SANDSTONE PRECINCT

23-39 BRIDGE STREET
SYDNEY NSW, 2000

**PROPOSED PLANS - LANDS BUILDING -
LOWER GROUND, EDUCATION BUILDING -
BASEMENT 01**

FOR APPROVAL

TITLE
**PROPOSED ELEVATIONS - LANDS BUILDING
- NORTH, EDUCATION BUILDING - NORTH**

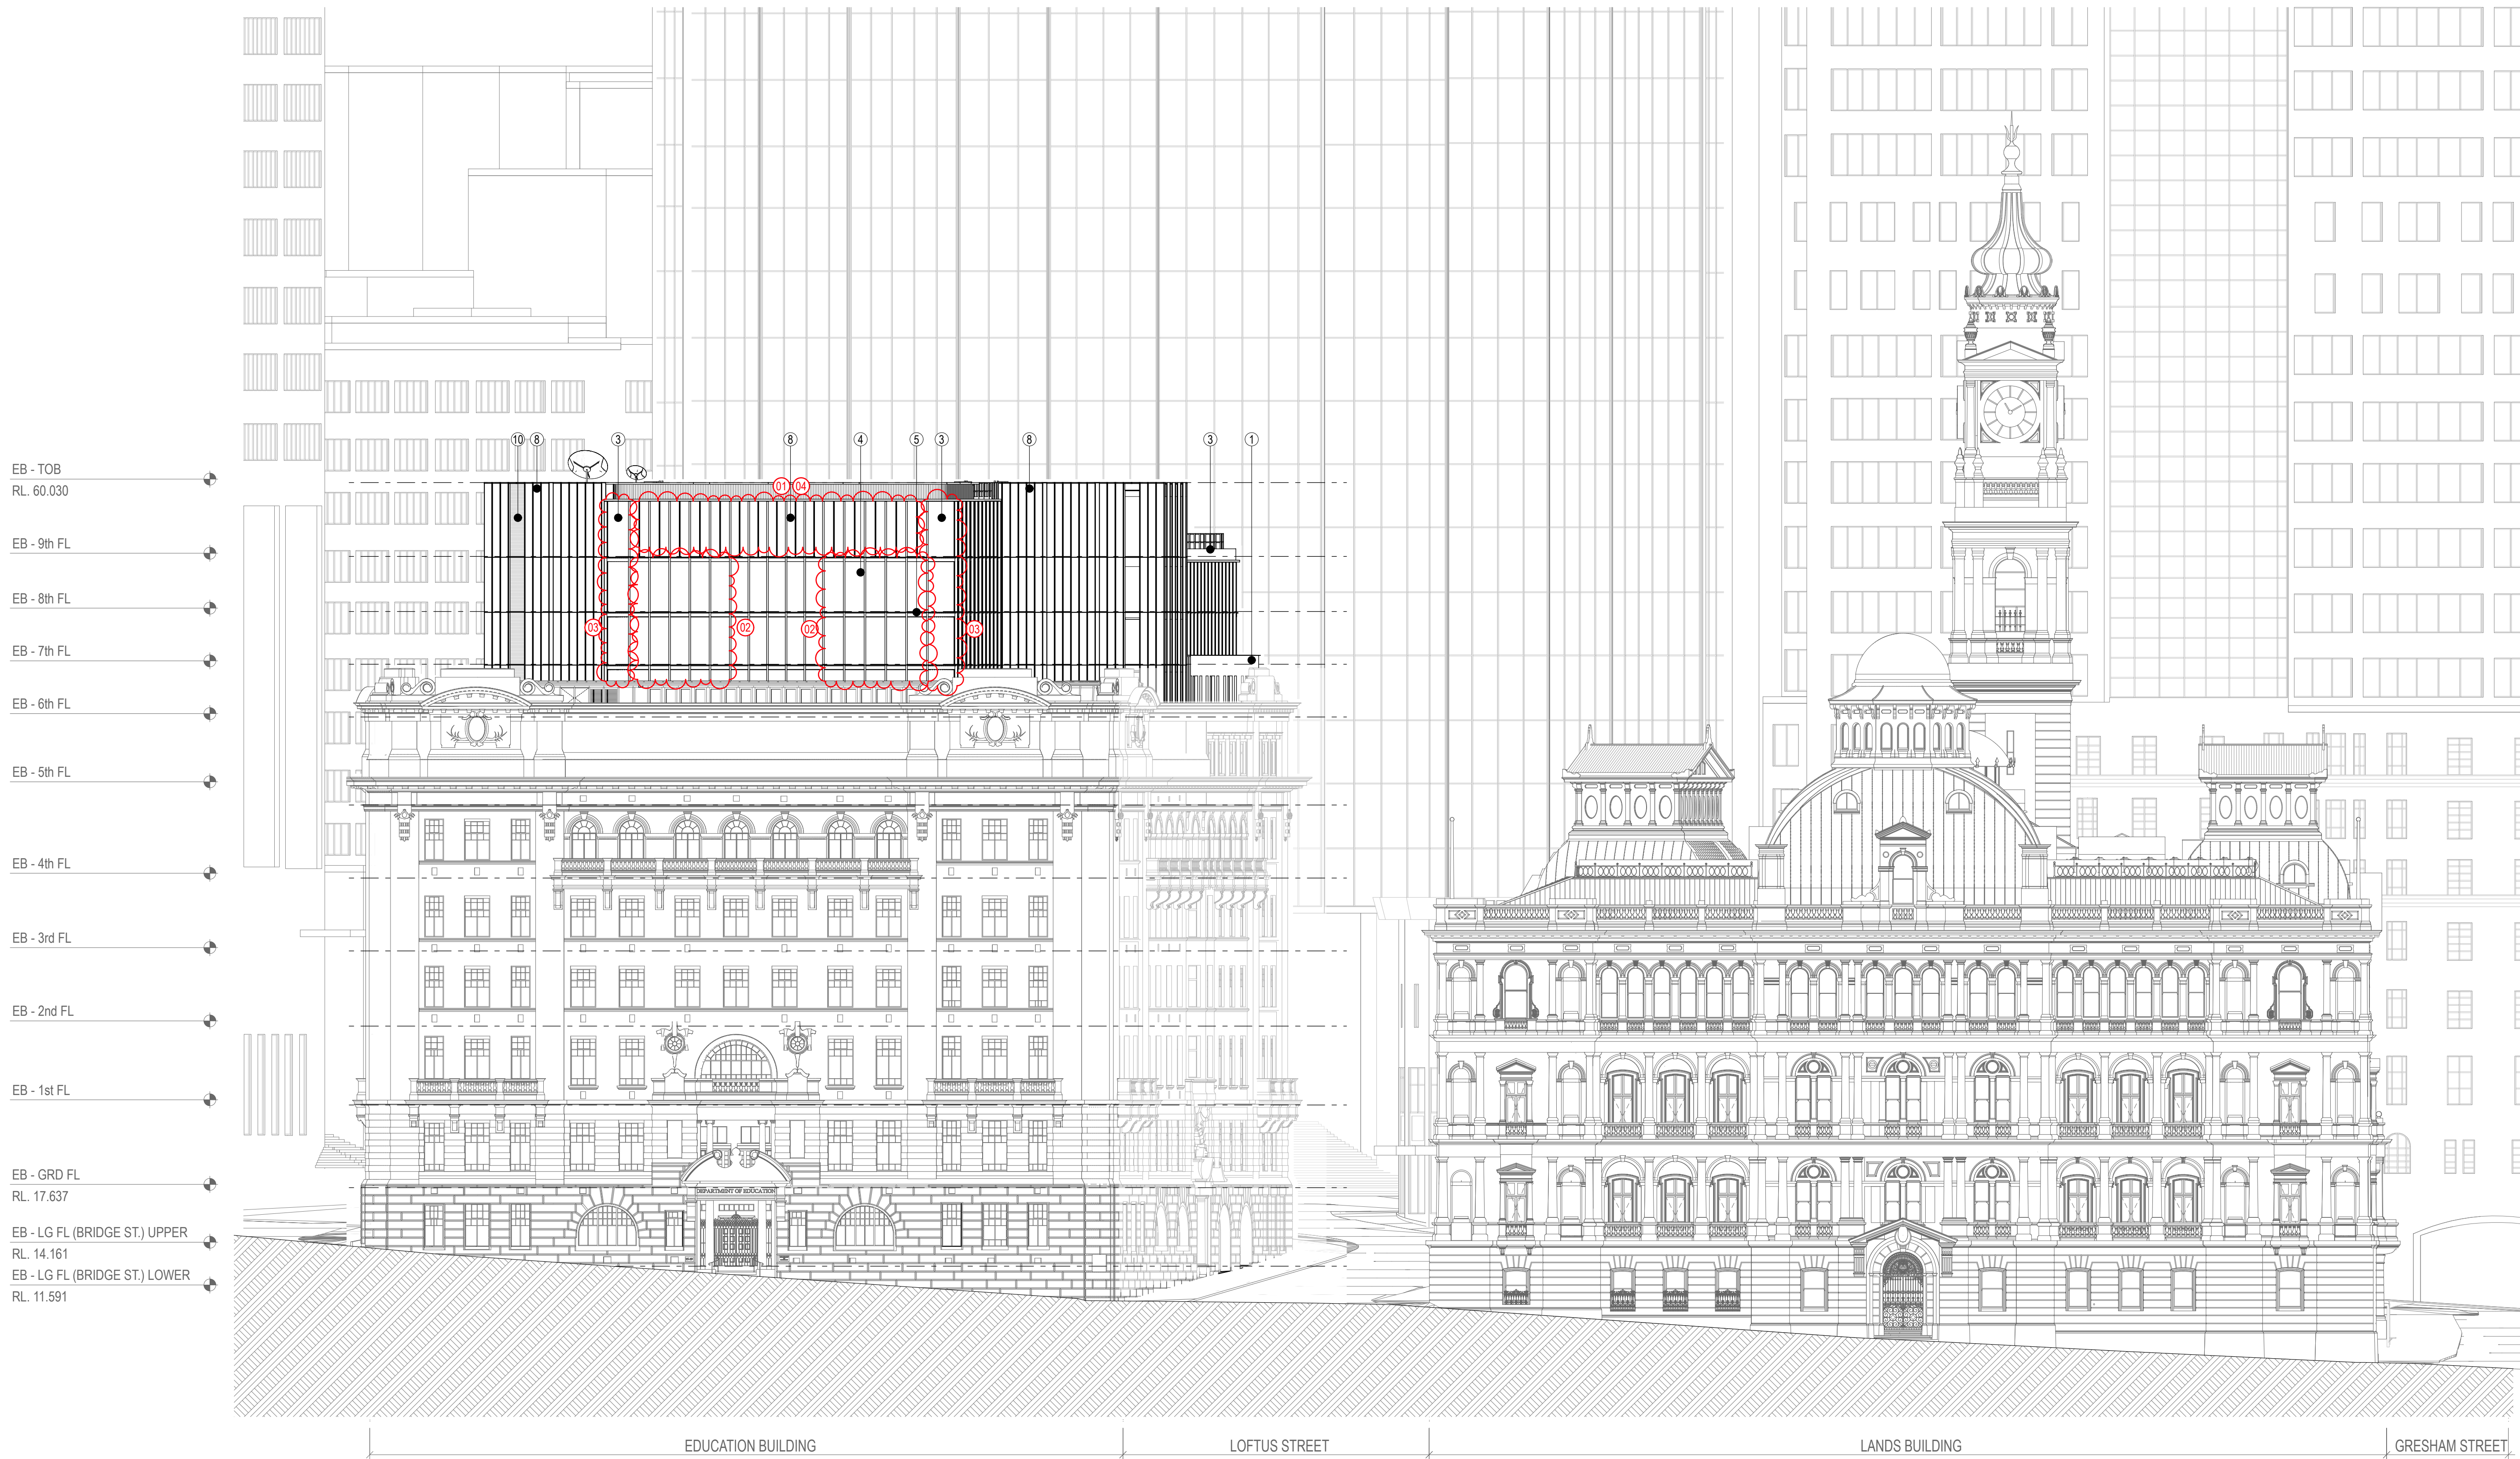
| 03 | CURVE GLASS CHANGED TO 1500MM RADIUS |
| 04 | UPDATED CLADDING SPACING |

TITLE
PROPOSED ELEVATIONS - EDUCATION BUILDING - COURTYARD

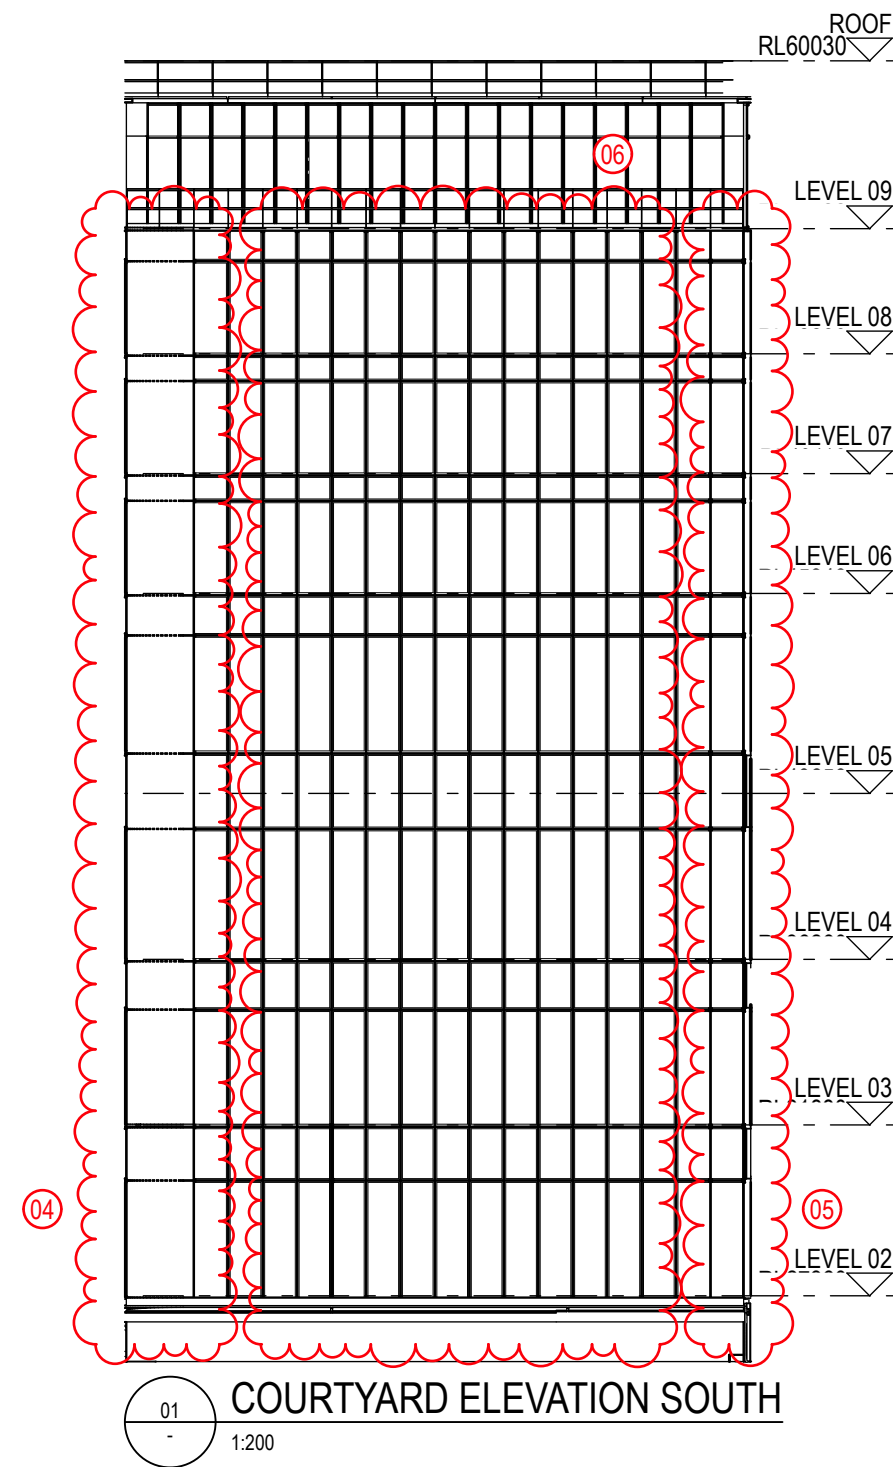
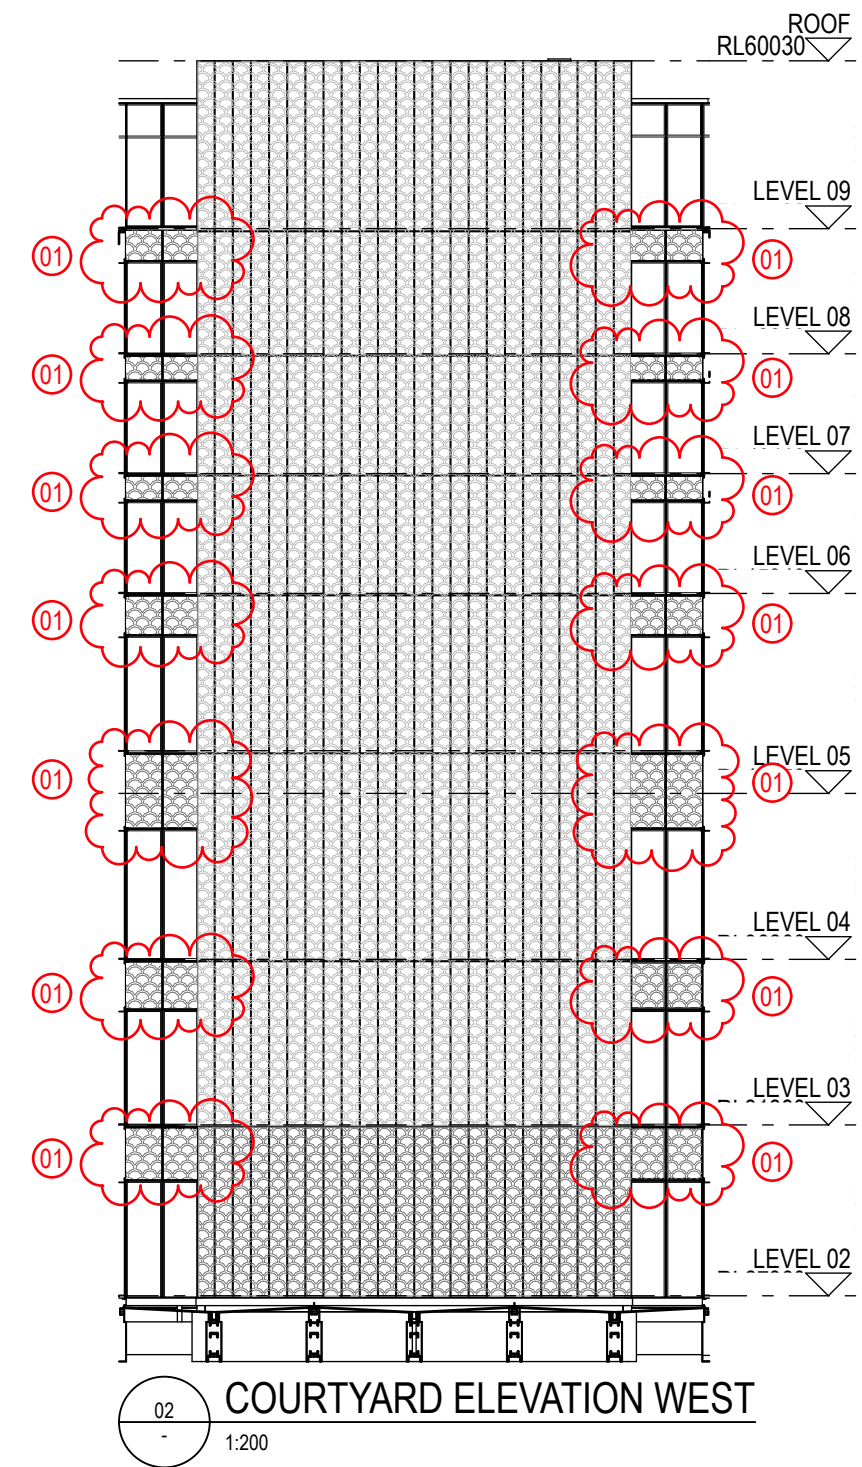
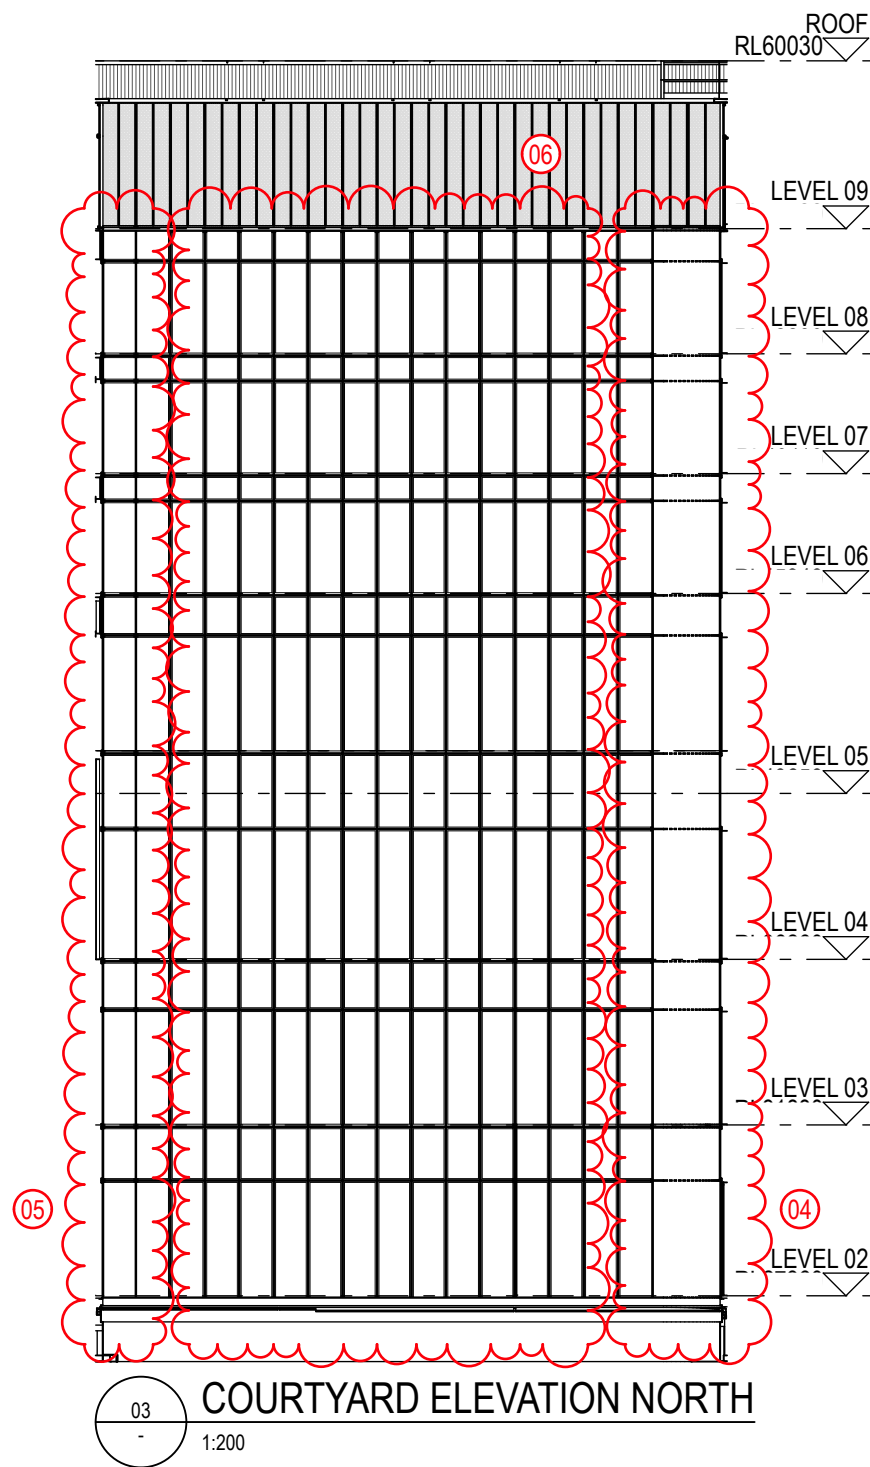
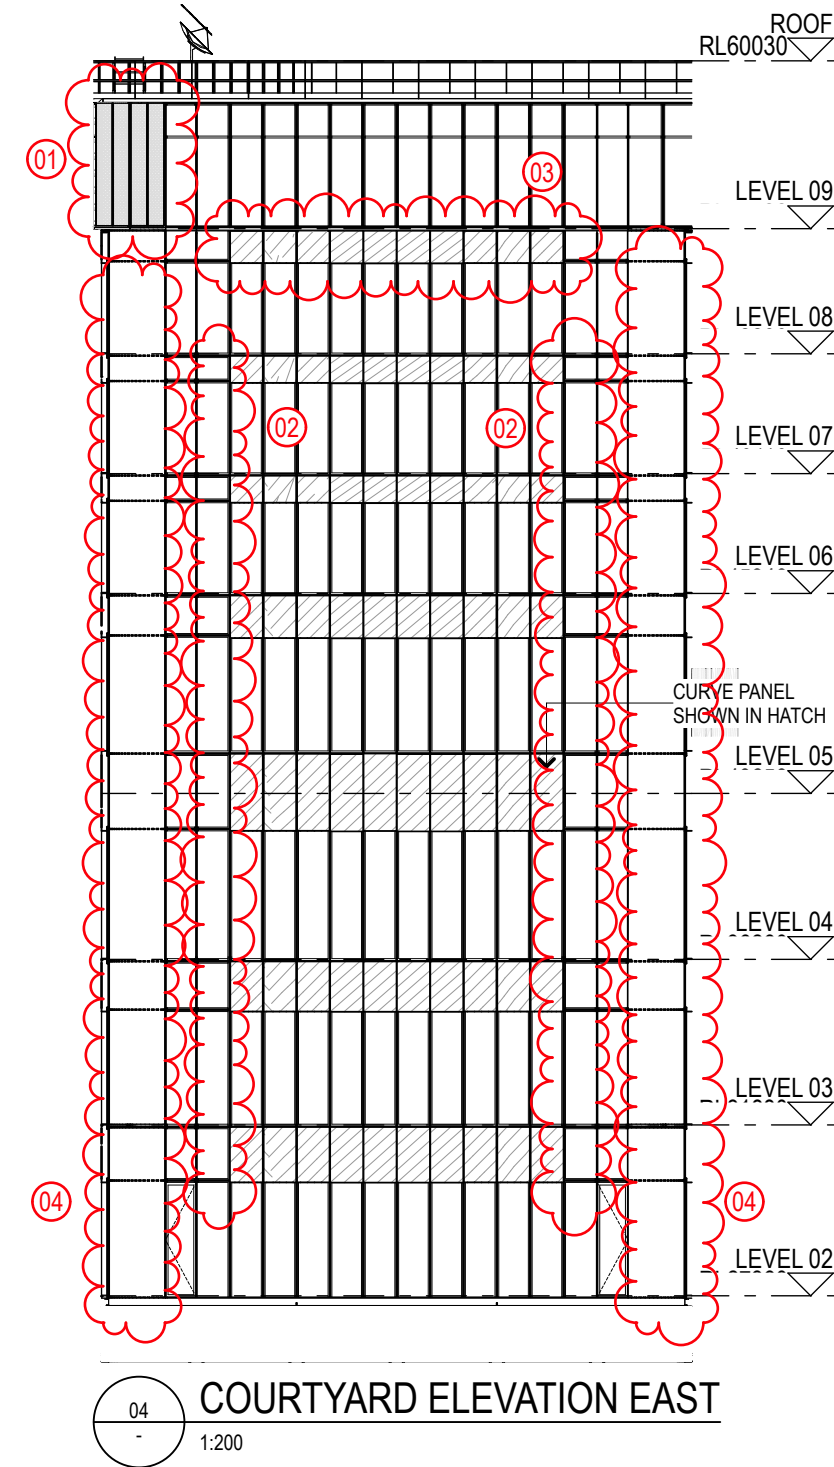
- 01 REPLACED GLAZED PANEL WITH FLUTED PERFORATED METAL PANEL
- 02 REMOVED AWNINGS, REPLACED WITH GLASS SPANDREL & BACKPAN
- 03 ADDED AWNINGS
- 04 CURVE GLASS CHANGED TO 1500MM RADIUS
- 05 CURVE GLASS REMOVED
- 06 CHANGED CURTAIN WALL SPACING
